RE: Request for Minor Project Modifications for DEP#204-0991, The Reconstruction of Foster Street in Littleton, MA.

PLAN MARKUP SHOWING PROPOSED CHANGES TO LEACHING CATCH  
BASINS

LITTLETON  
RECONSTRUCTION OF FOSTER STREET

DRAINAGE & UTILITY PLANS

| STATE            | FED. AID PROJ. NO.     | SHEET NO. | TOTAL SHEETS |
|------------------|------------------------|-----------|--------------|
| MA               | STP/CMQ/TAP-0033(037)X | 57        | 128          |

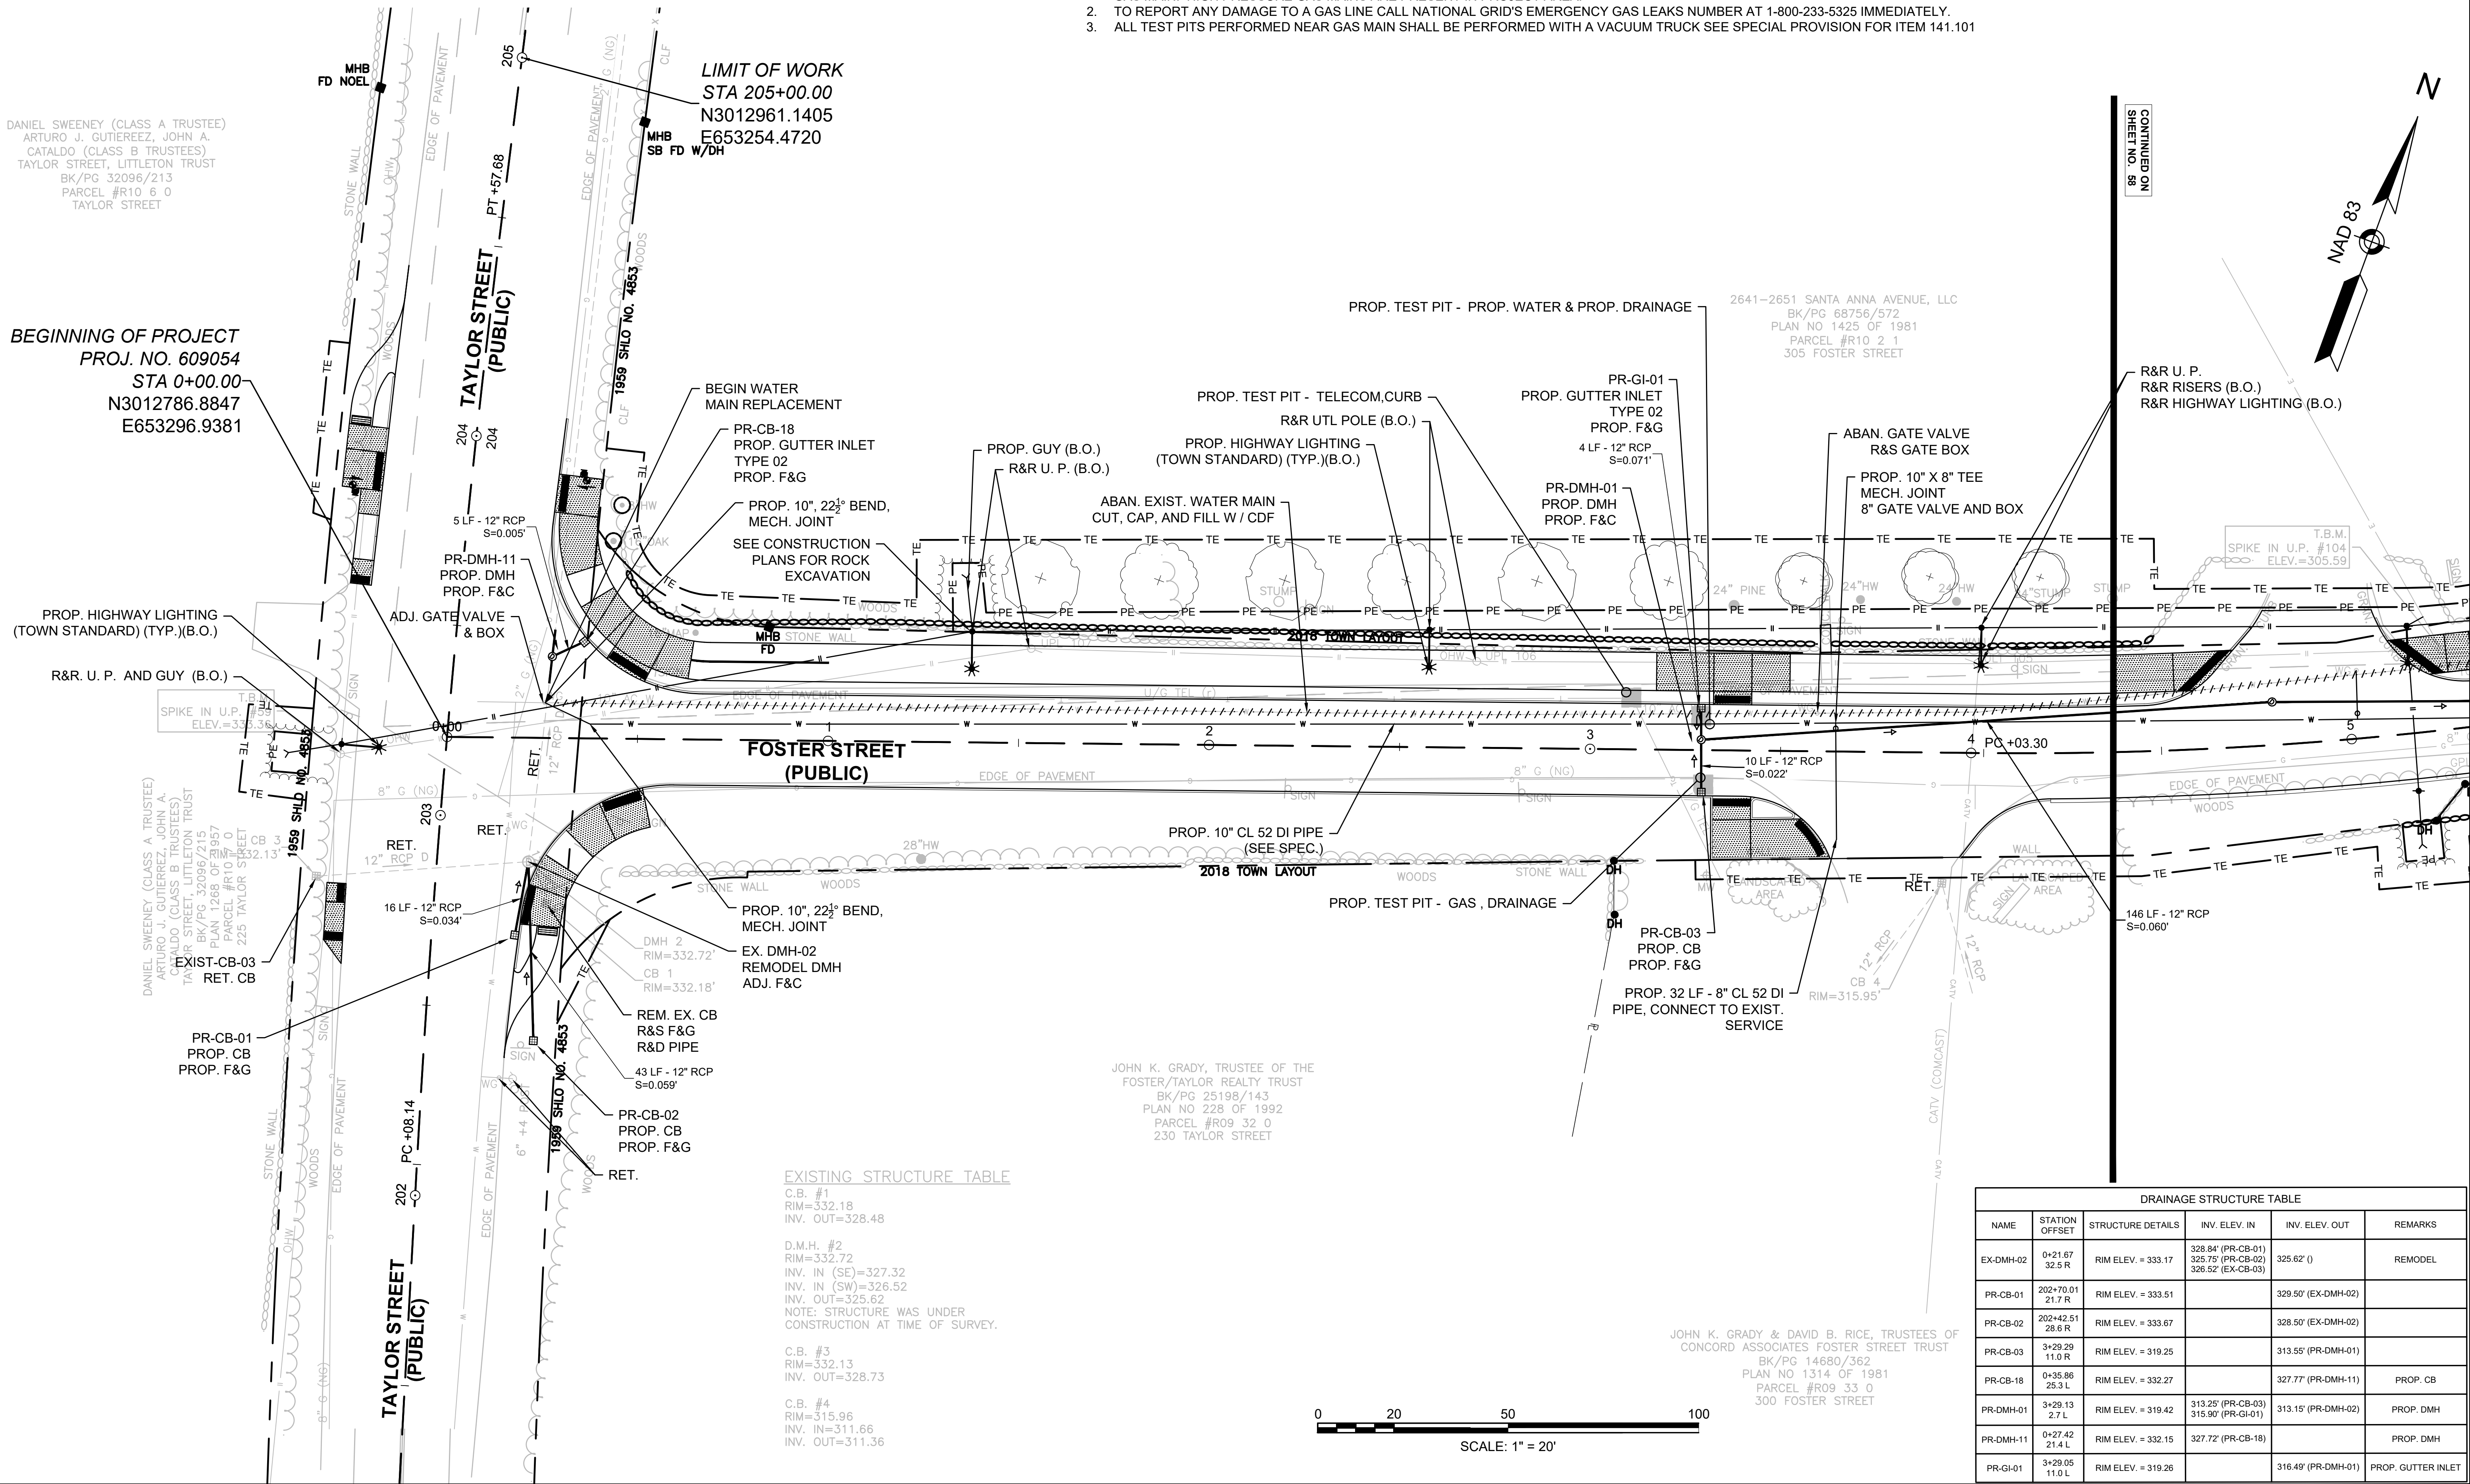
NOTE: GROUND WATER MUST BE 8.5' BELOW SURFACE FOR LEACHING CATCH BASIN INSTALLATION.

LOCATION OF LEACHING BASIN-01  
ESTIMATED SEASONAL HIGH GROUND WATER DEPTH 4.0' BELOW SURFACE  
LEACHING CATCH BASIN NOT FEASIBLE  
DEEP SUMP CATCH BASIN CBDB-01 TO REMAIN IN ROAD.

| STATE            | FED. AID PROJ. NO.     | SHEET NO. | TOTAL SHEETS |
|------------------|------------------------|-----------|--------------|
| MA               | STP/CMQ/TAP-0033(037)X | 59        | 128          |

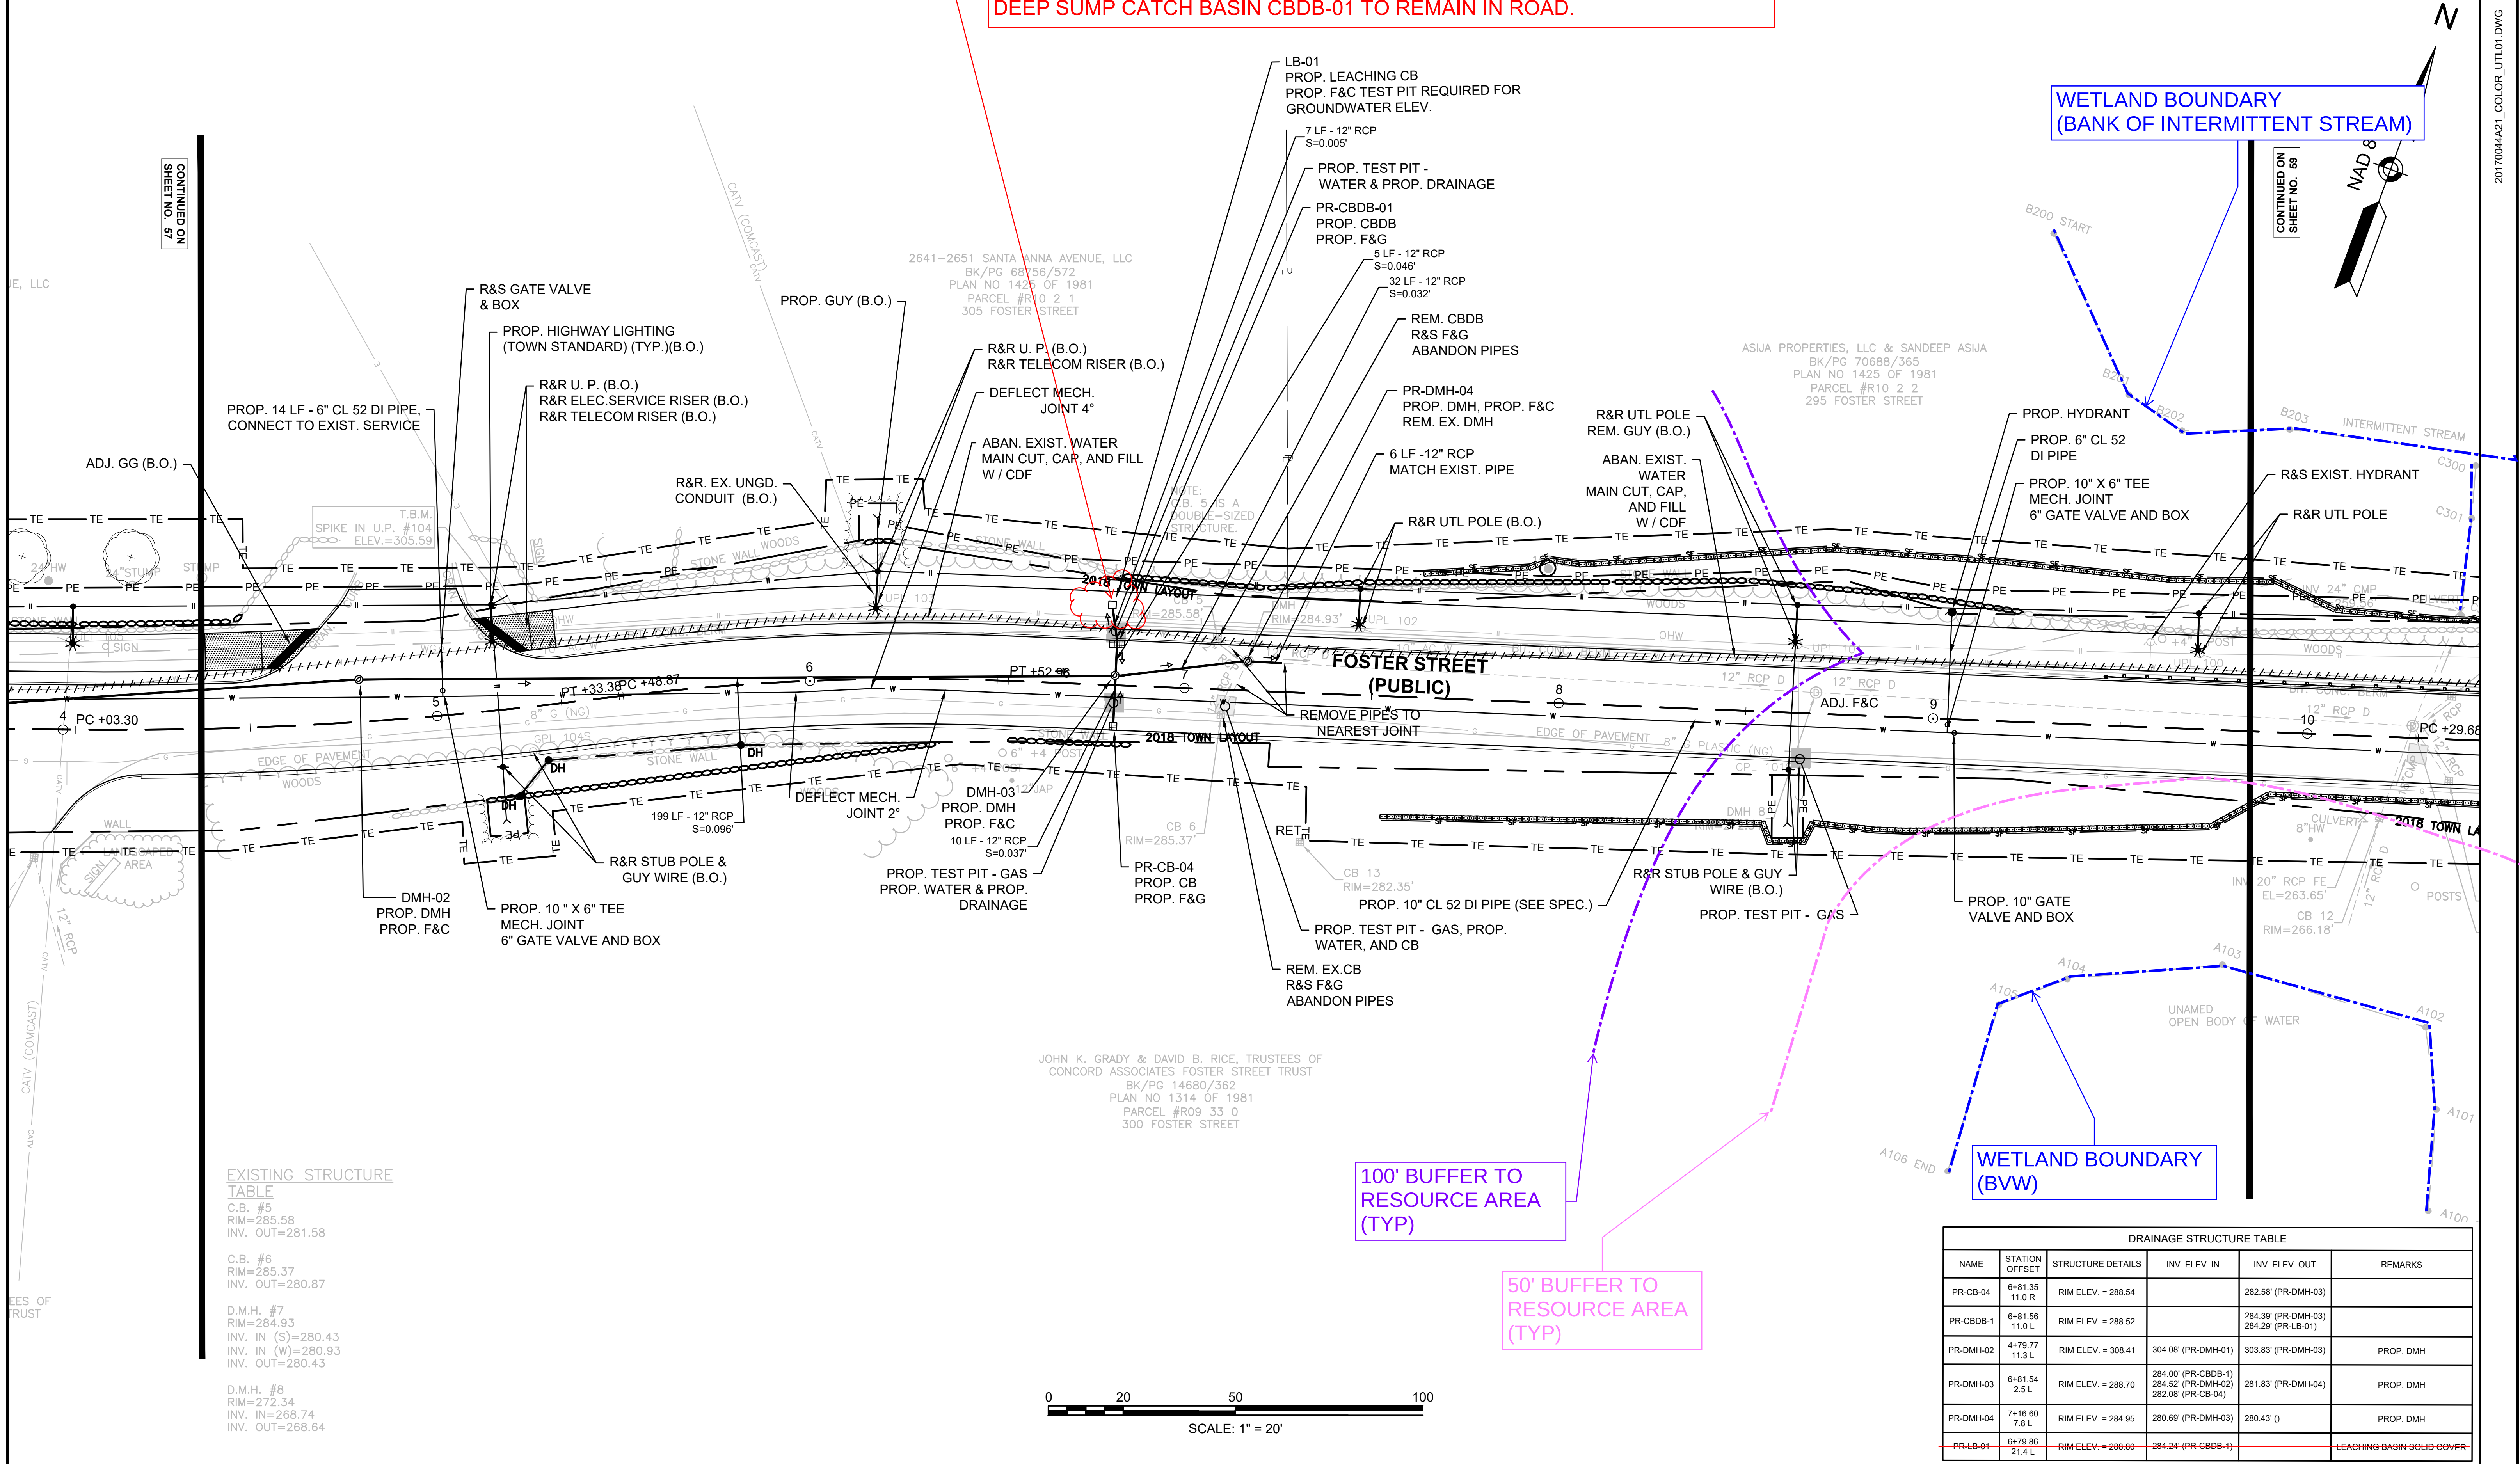
LOCATION OF LEACHING BASIN-02  
ESTIMATED SEASONAL HIGH GROUND WATER DEPTH 5.0' BELOW SURFACE  
LEACHING CATCH BASIN NOT FEASIBLE  
DEEP SUMP CATCH BASIN CB-06 TO REMAIN IN ROAD.

| STATE            | FED. AID PROJ. NO.     | SHEET NO. | TOTAL SHEETS |
|------------------|------------------------|-----------|--------------|
| MA               | STP/CMQ/TAP-0033(037)X | 60        | 128          |

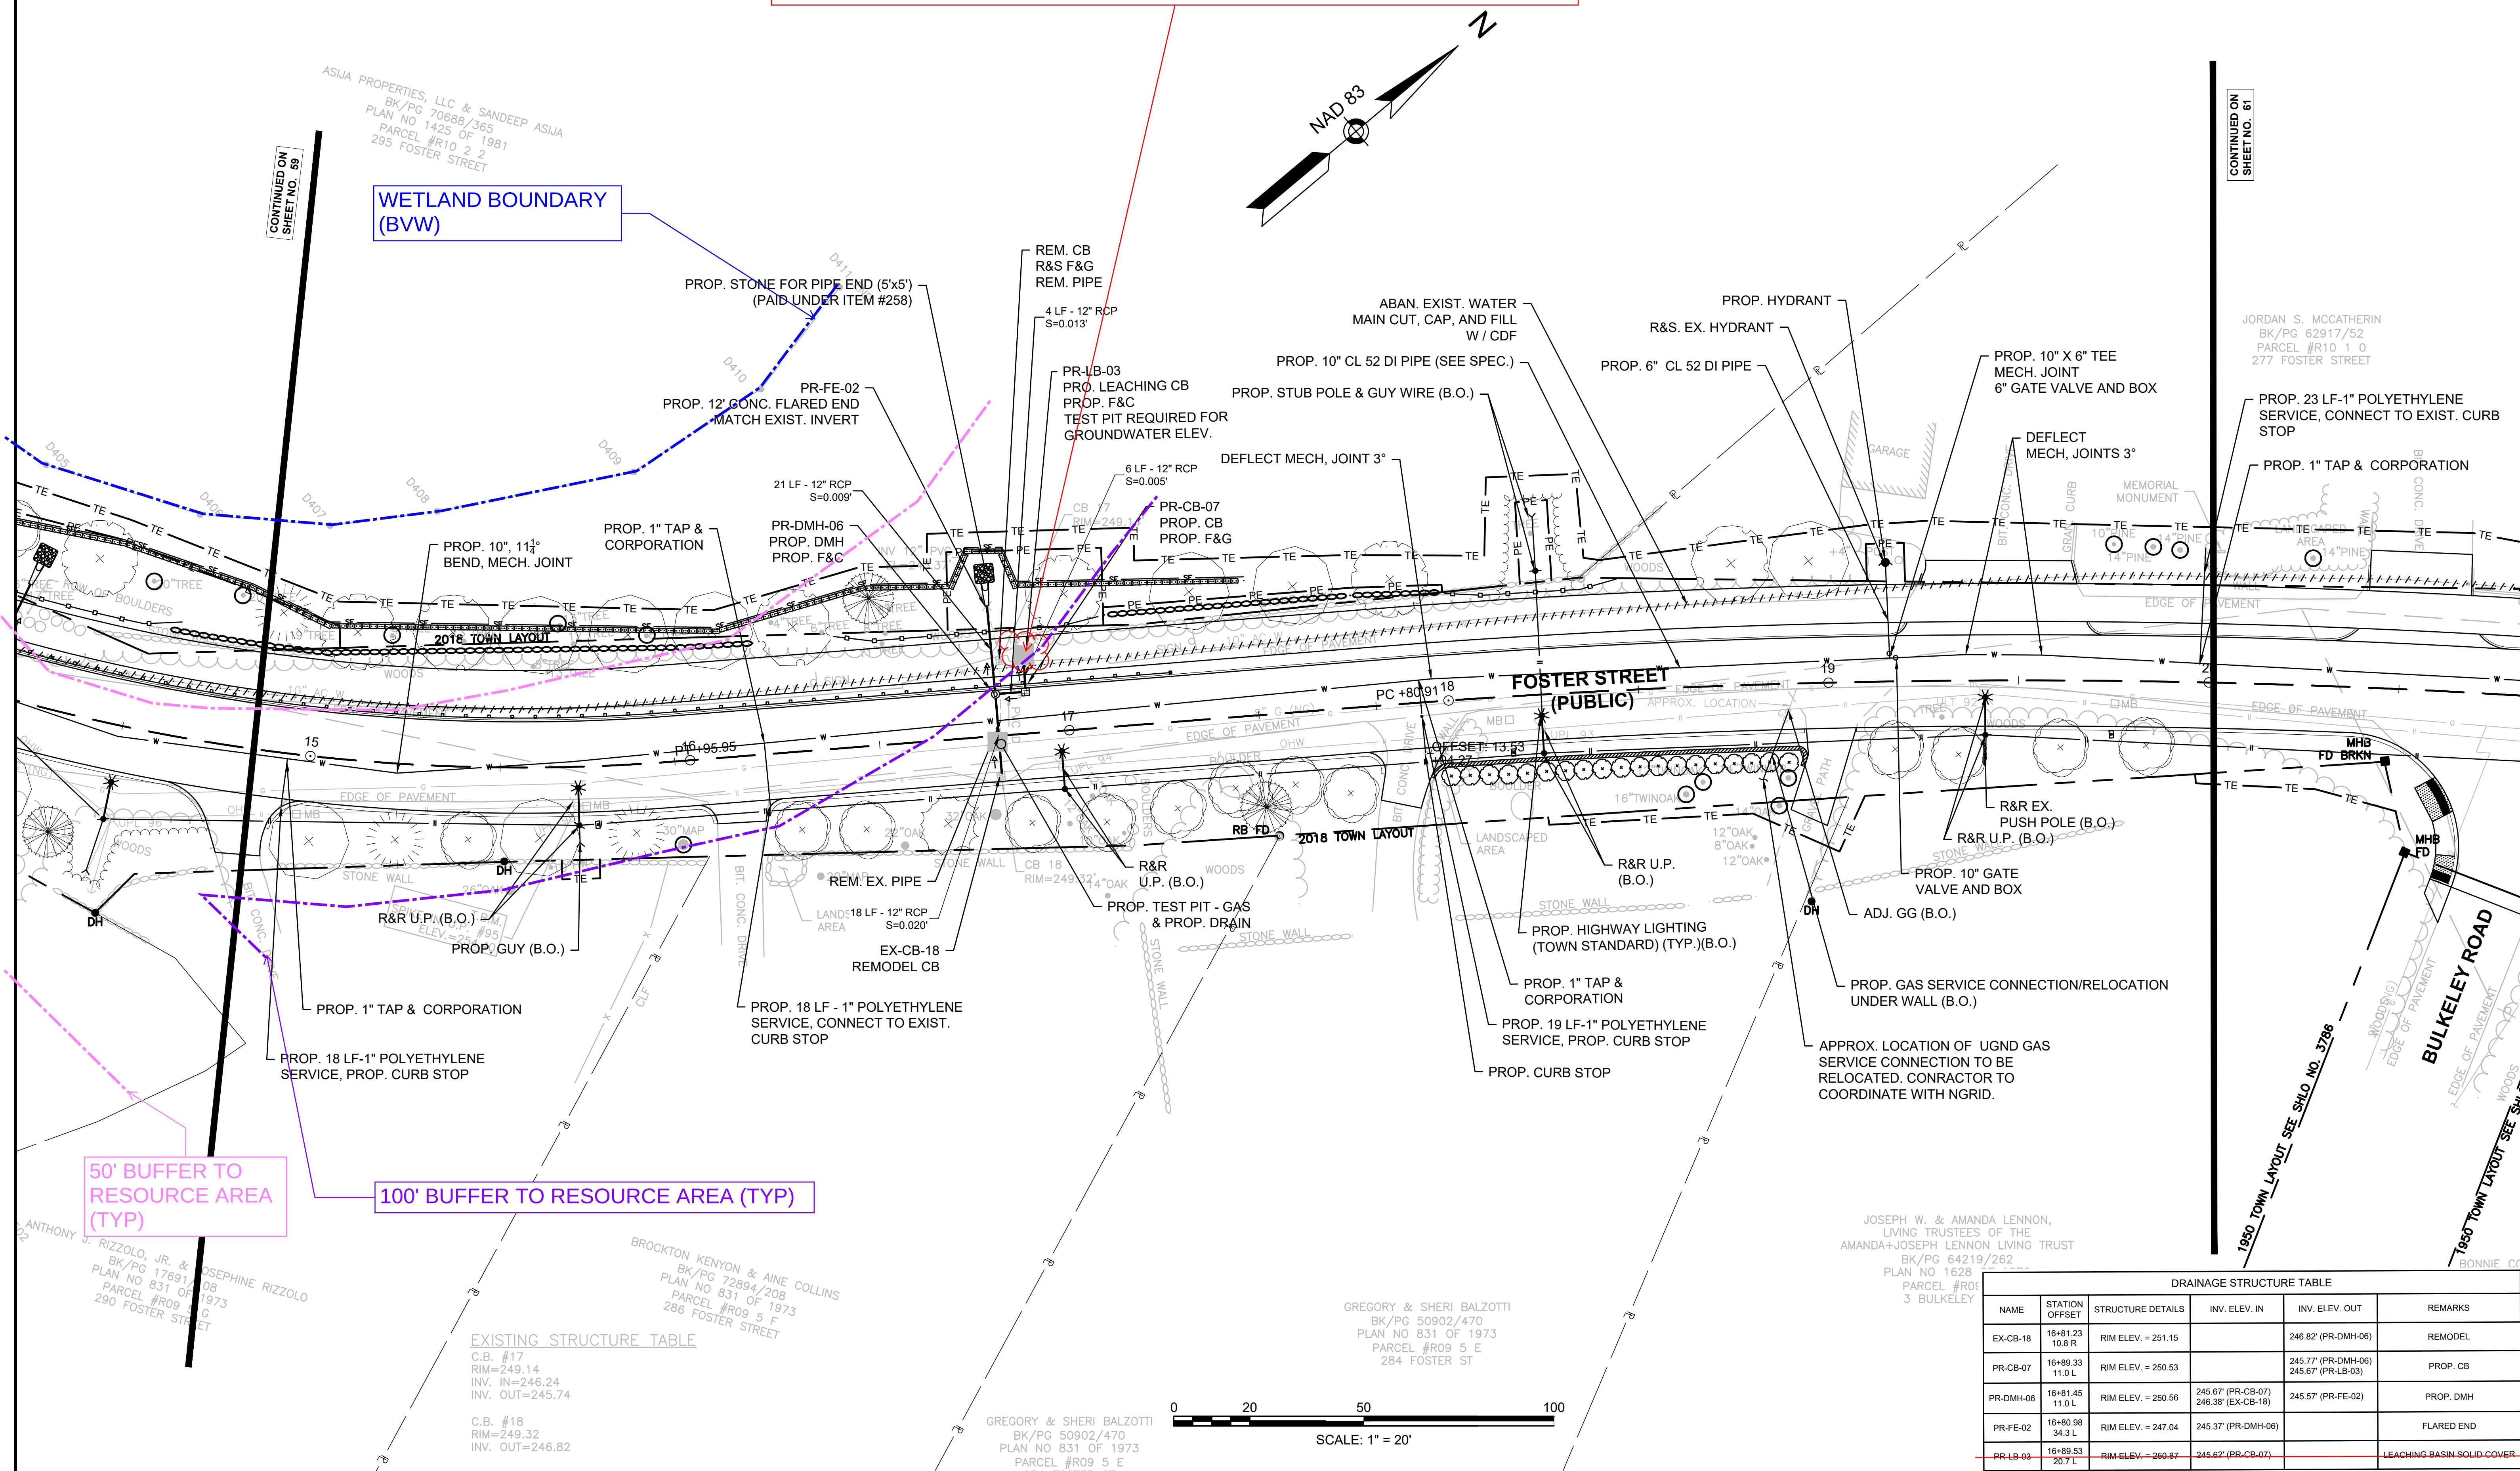
LOCATION OF LEACHING BASIN-03  
ESTIMATED SEASONAL HIGH GROUND WATER DEPTH 3.2' BELOW SURFACE  
LEACHING CATCH BASIN NOT FEASIBLE  
DEEP SUMP CATCH BASIN CB-07 TO REMAIN IN ROAD.
